# UNITED STATES PATENT AND TRADEMARK OFFICE

APPLICATION NO.	FILING DATE	FIRST NAMED INVENTOR	ATTORNEY DOCKET NO.	CONFIRMATION NO.
10/573,449	01/19/2007	Akira Takaguchi	1082/HIROSE	2452
27649	7590	03/16/2010	EXAMINER	
MICHAEL TOBIAS 1629 K ST NW SUITE 300 WASHINGTON, DC 20006			MEHTA, MEGHA S	
			ART UNIT	PAPER NUMBER
			1793	
			MAIL DATE	DELIVERY MODE
			03/16/2010	PAPER

<b>Office Action Summary</b>	<b>Application No.</b> 10/573,449	<b>Applicant(s)</b> TAKAGUCHI ET AL.	
	<b>Examiner</b> MEGHA MEHTA	<b>Art Unit</b> 1793

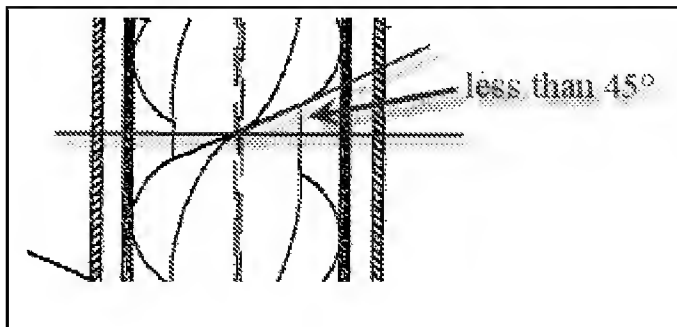
Regarding claim 13, Gerstenberg teaches that each of the blades is sloped by at most  $45^\circ$  with respect to a plane perpendicular to a rotational axis of the hub (shown in figure 1 to the right).
